UNITED STATES PATENT AND TRADEMARK OFFICE

10/529,370

Vasilios Orizaris

Office Action Summary

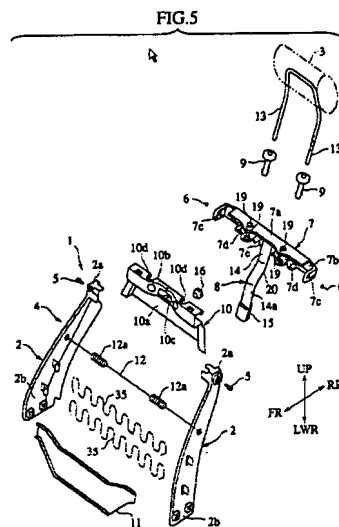
12. In re Claim 17, Cziptschirsch et al disclose that the swivel movement of the impact plate is limited (col. 1, lines 28-30). The head support (4) would inherently make, two-dimensional contact of the head on the head support (4) in the event of an accident due to the adjustable nature of the head support.

13. In re Claim 18, Cziptschirsch et al disclose that the connection element (1,2) is curved (col. 2, lines 28-30).
